BOUYGUES MARK UP
PRIVACY SCREEN LOCATIONS
A.PETRASEVIC 19/02/2020

Mount Pleasant Phase 1
Upper Ground Plan

PROJECT	ISSUER	AREA	LEVEL	TYPE	TRADE	SEQUENCE	REV
MP1	BMA	BA1	UG	GA	A31	103003	N

1 00 Upper Ground Level GA
Scale 1 : 200

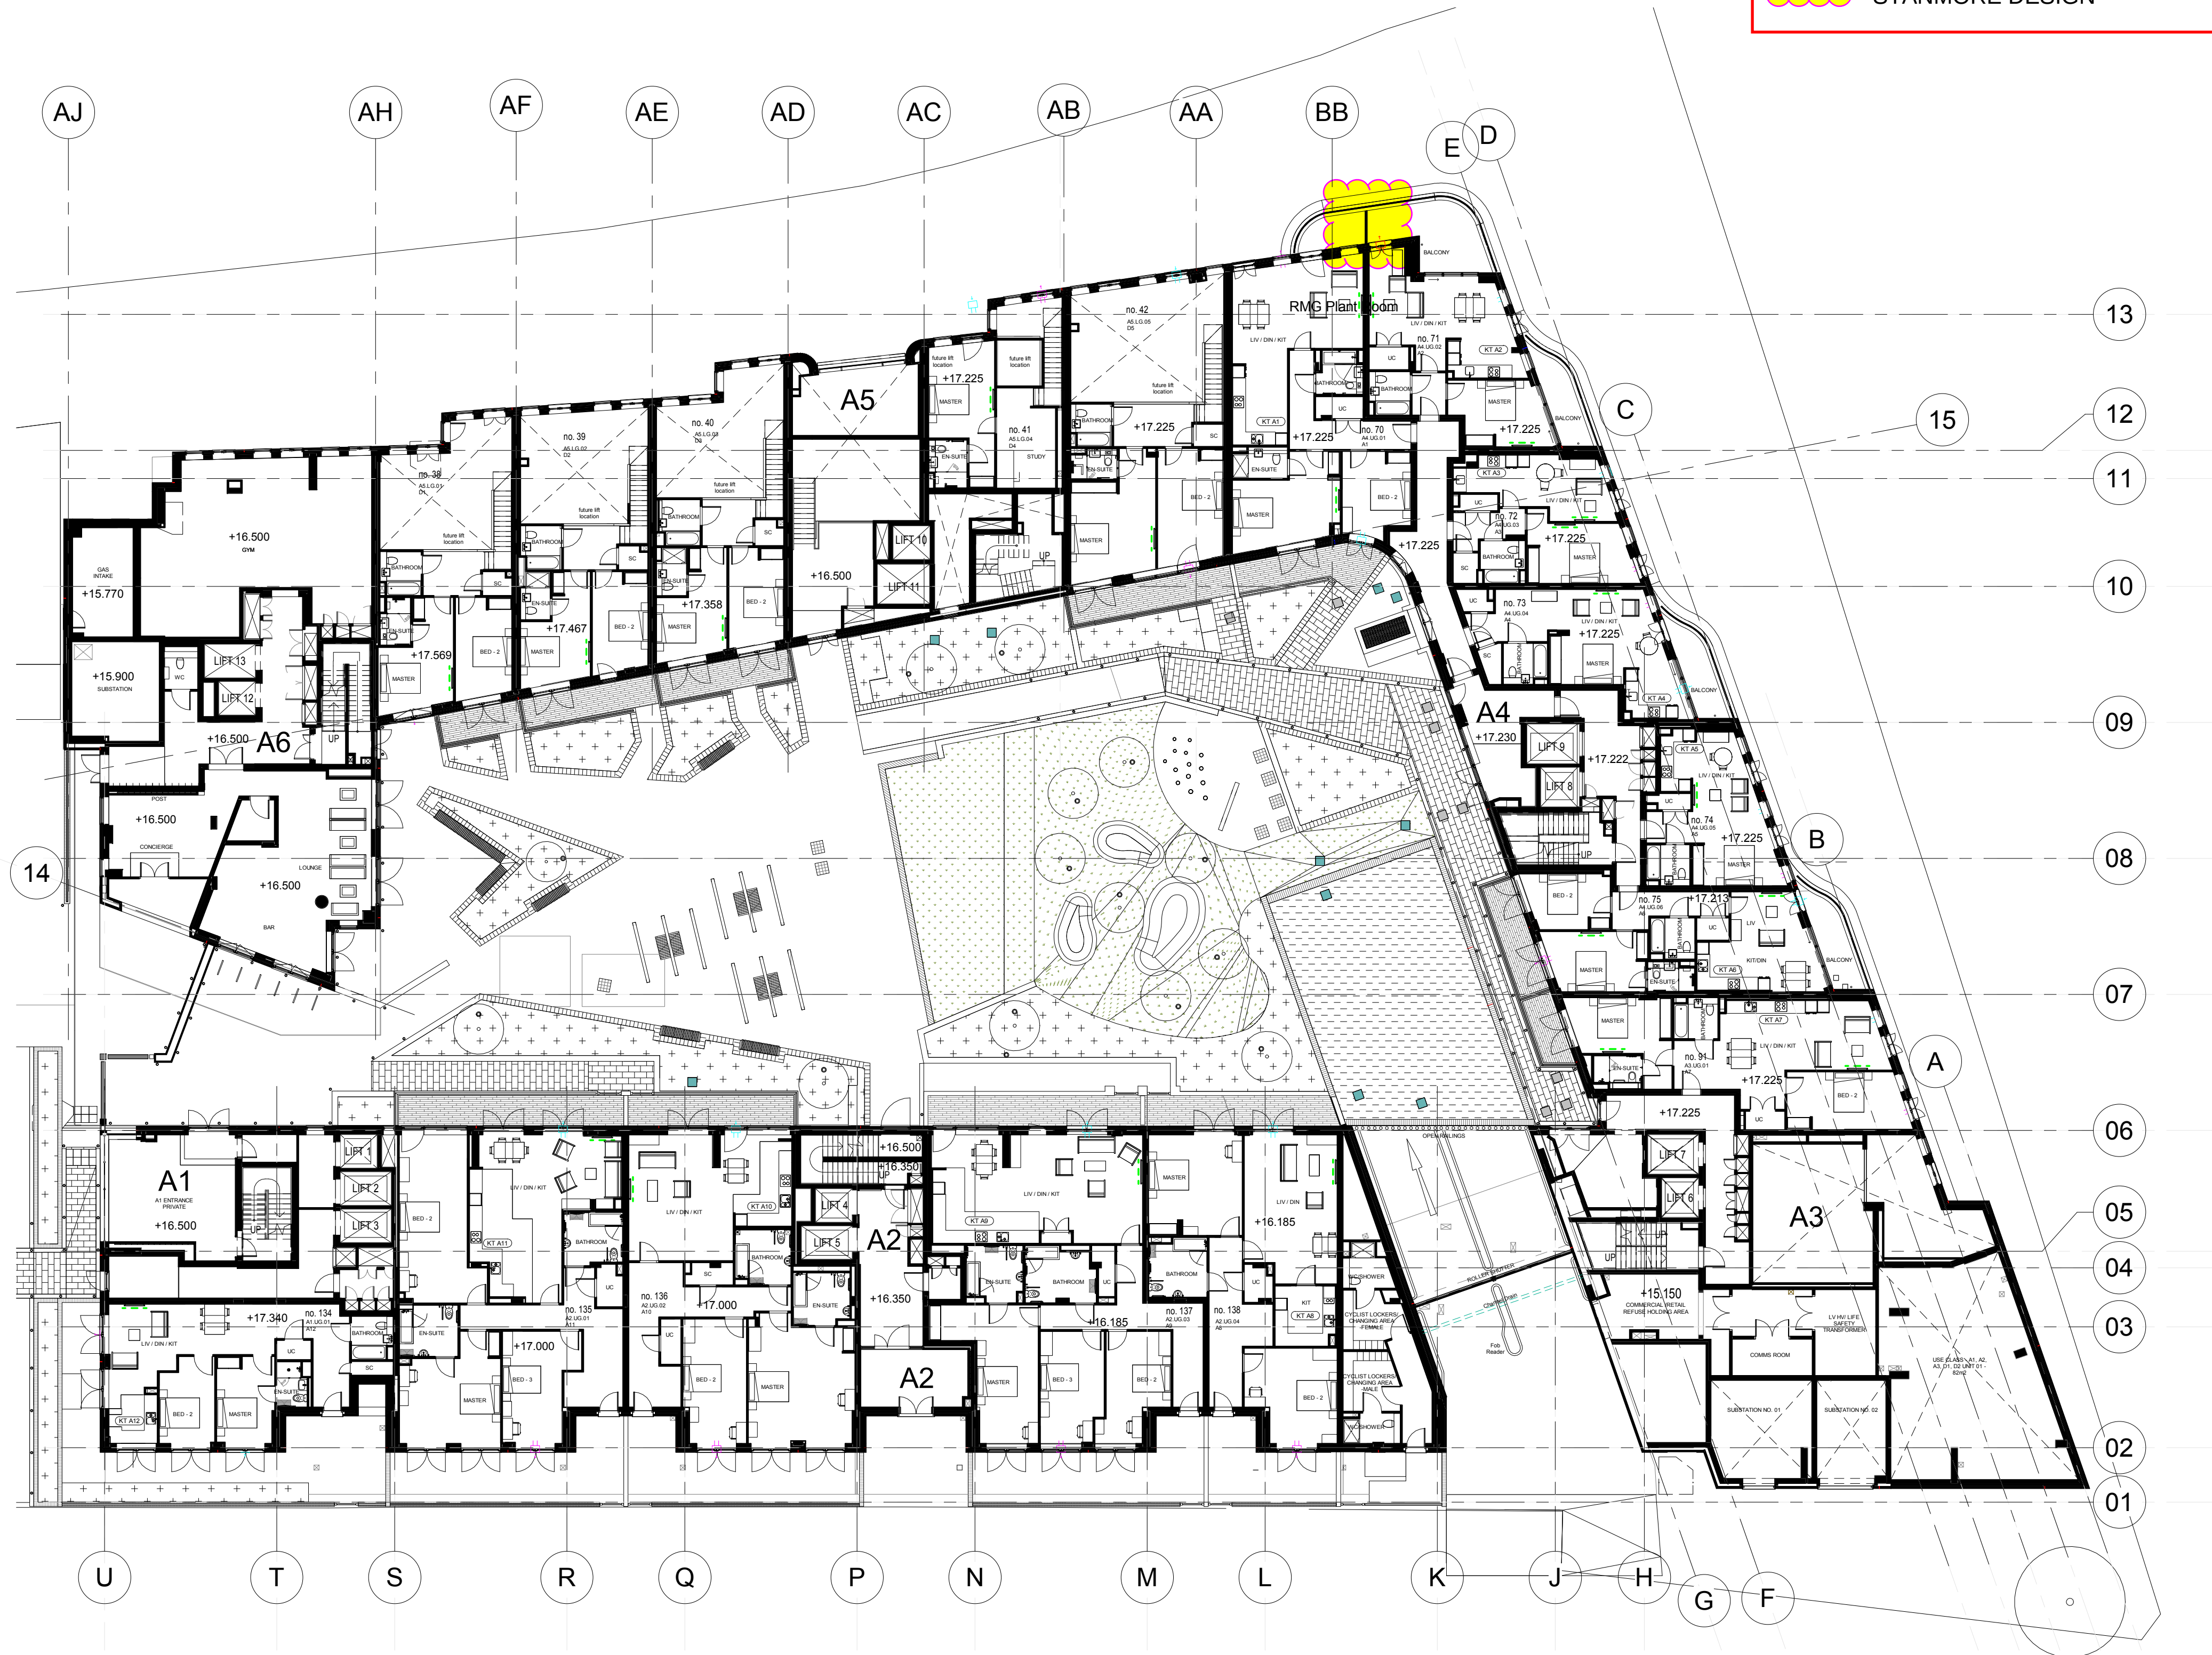
HIGHLIGHTED AREA SHOWS LOCATION
OF PRIVACY SCREEN AS PER
STANMORE DESIGN
